# Technical Document RA19016

Application under the *Agricultural Operation Practices Act* for a confined feeding operation, manure collection area and/or manure storage facility(ies)

<b>NRCB USE ONLY</b>		Application number	Legal land description
<input type="checkbox"/> Approval	<input type="checkbox"/> Registration	<input checked="" type="checkbox"/> Authorization	
<input type="checkbox"/> Amendment		RA19016	SE-2-43-25 WH

### ADS CANADA N-12 WT IB JOINT SYSTEM

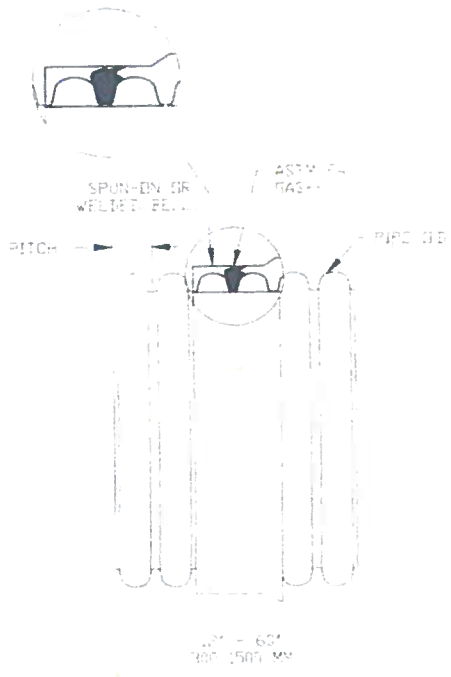
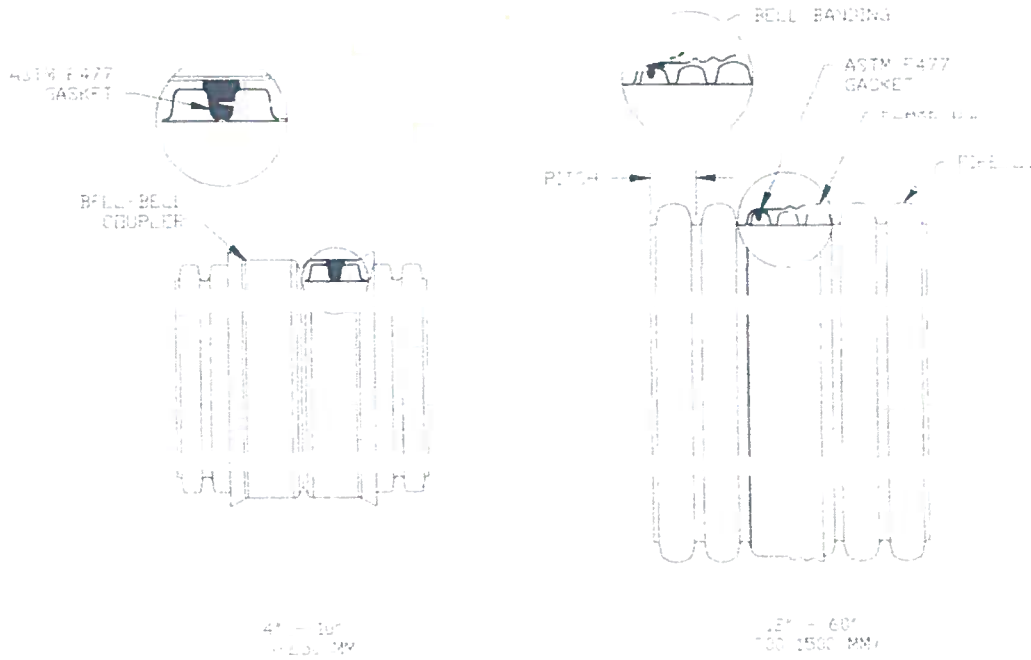
A condition will be added to the permit requiring submission of proof, prepared by a qualified third party, that the pipe and sealants used in the barn addition are the same or equivalent to what is proposed.
